MATERIAL CHANGES:

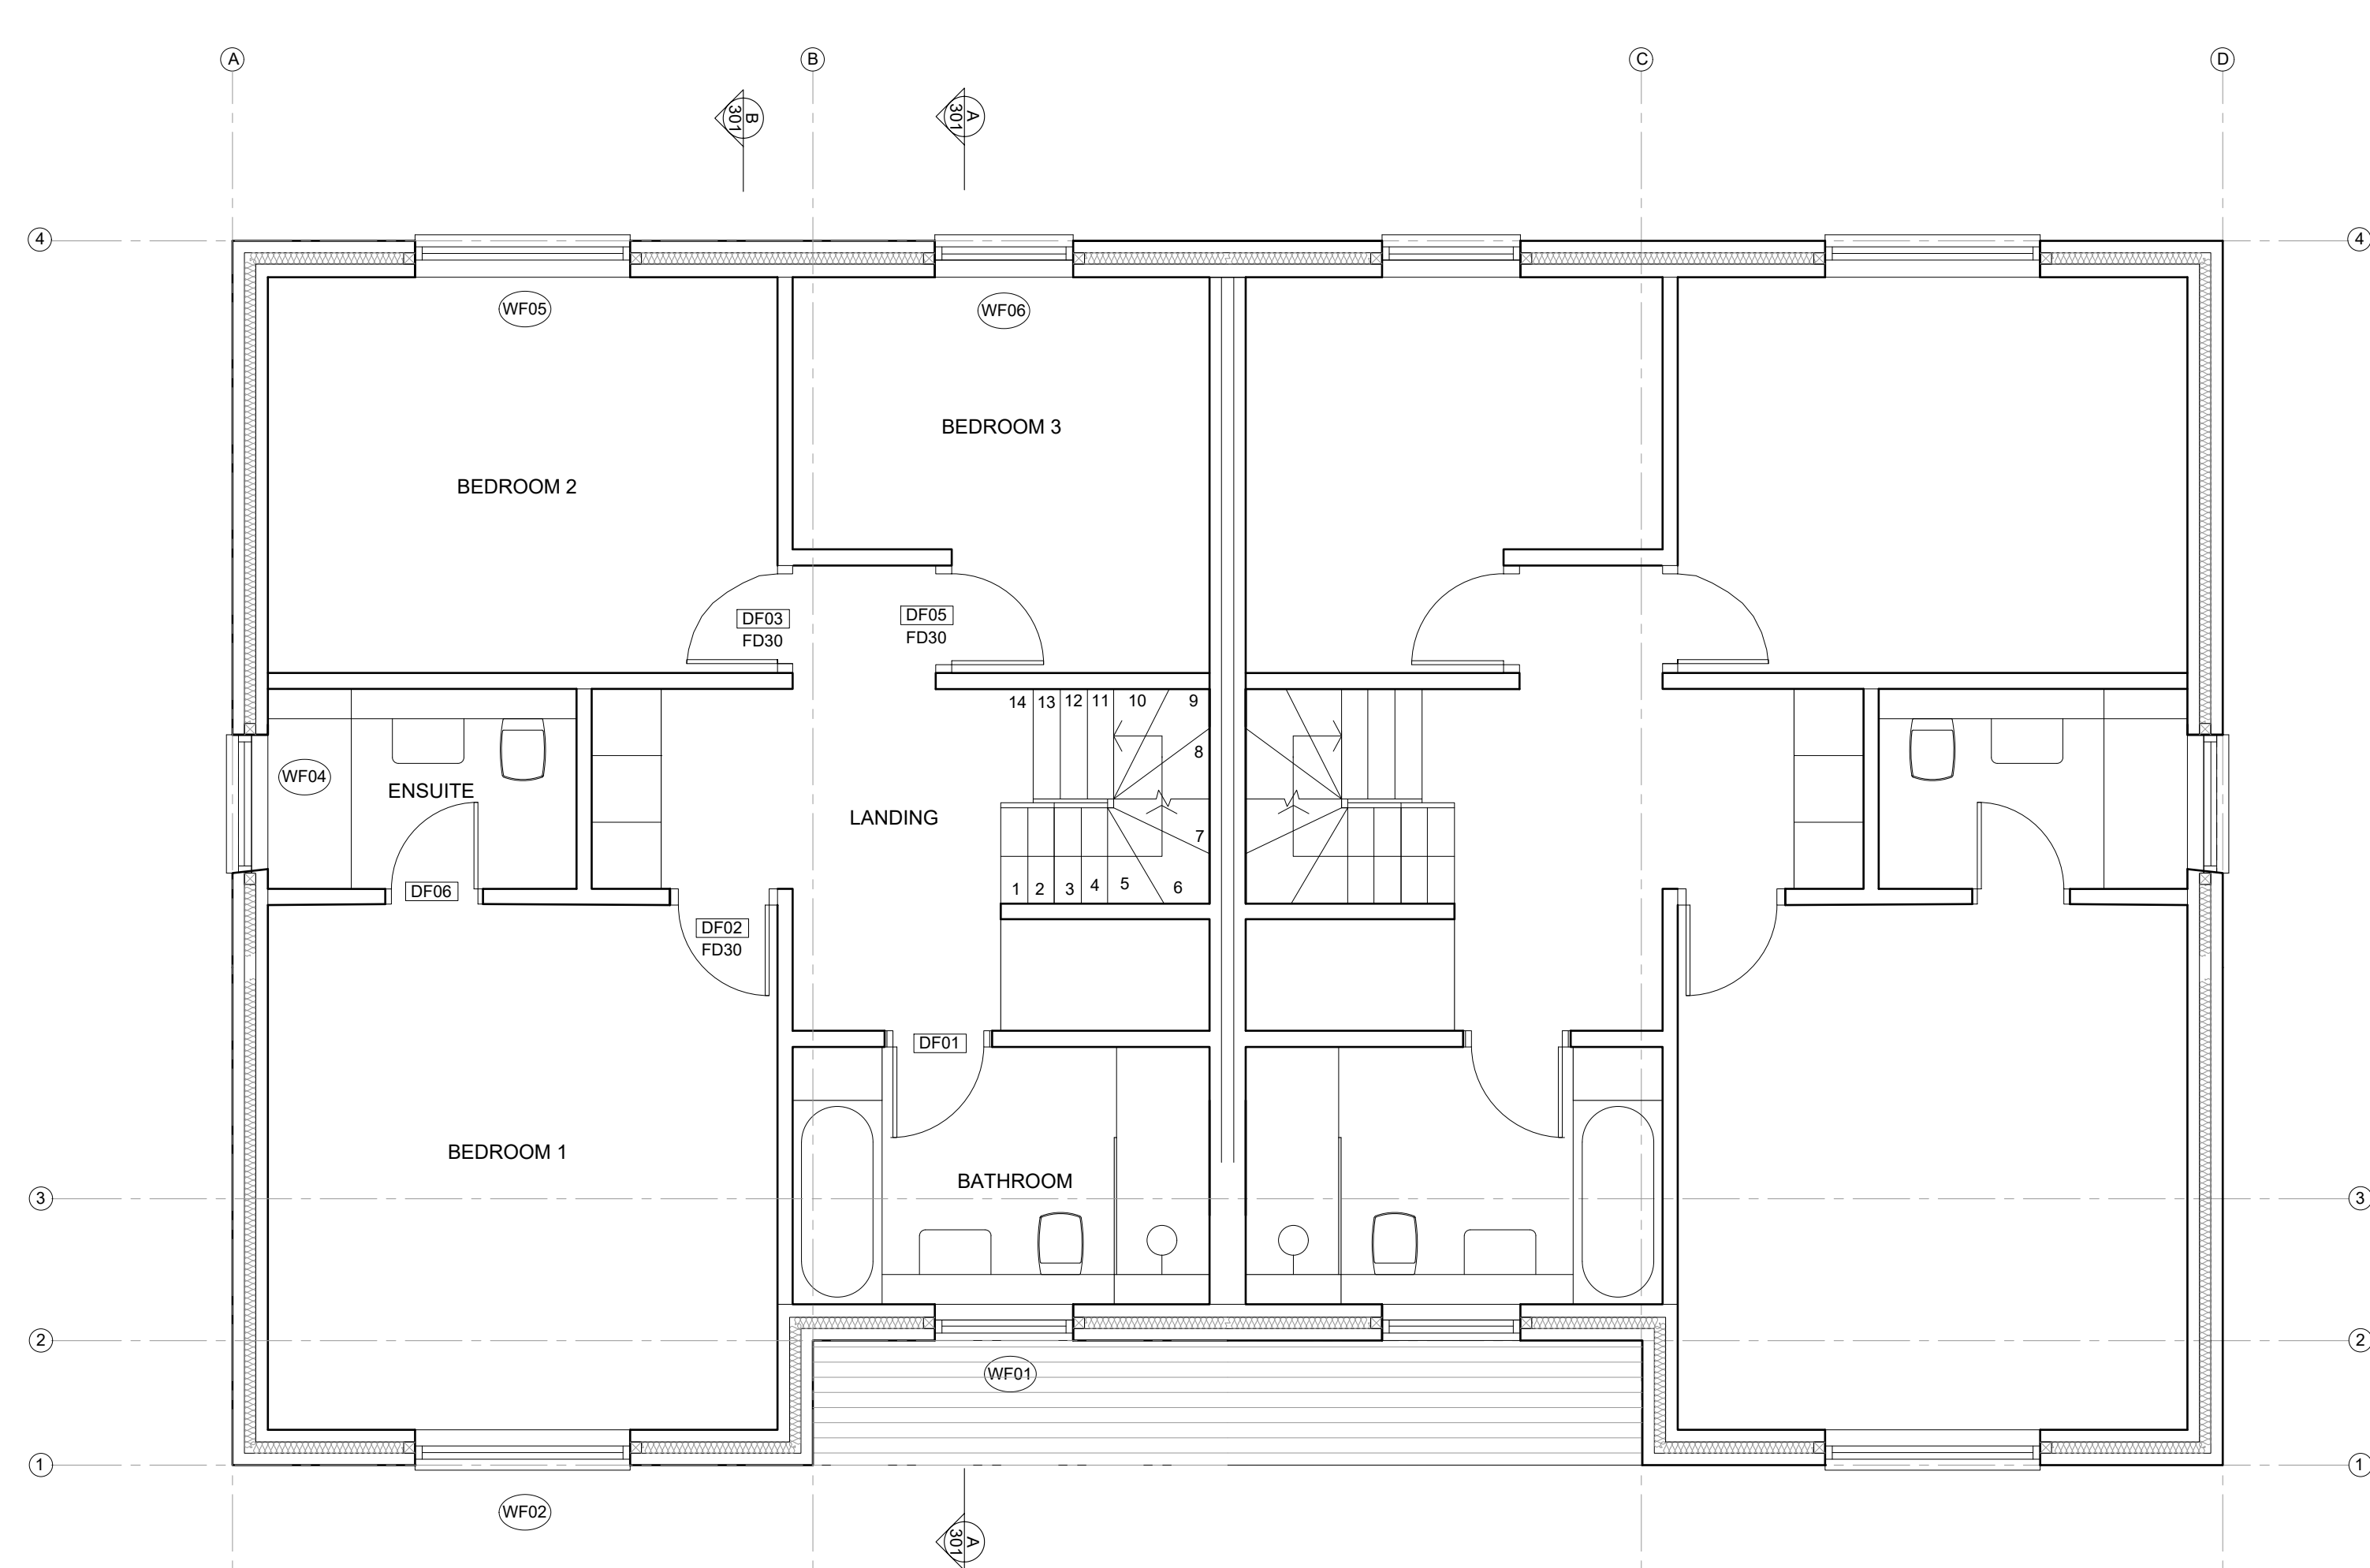
1. FRONT WALL BETWEEN TWO PROJECTING BAYS ON THE FIRST FLOOR HAS BEEN BROUGHT FORWARD AND THE ROOF ADJUSTED TO SUIT THE NEW SETTING OUT FOR THE WALL PLATE.
2. THE FLAT ROOF DORMERS TO THE REAR OF THE HOUSE HAVE BEEN ENLARGED (WIDENED)
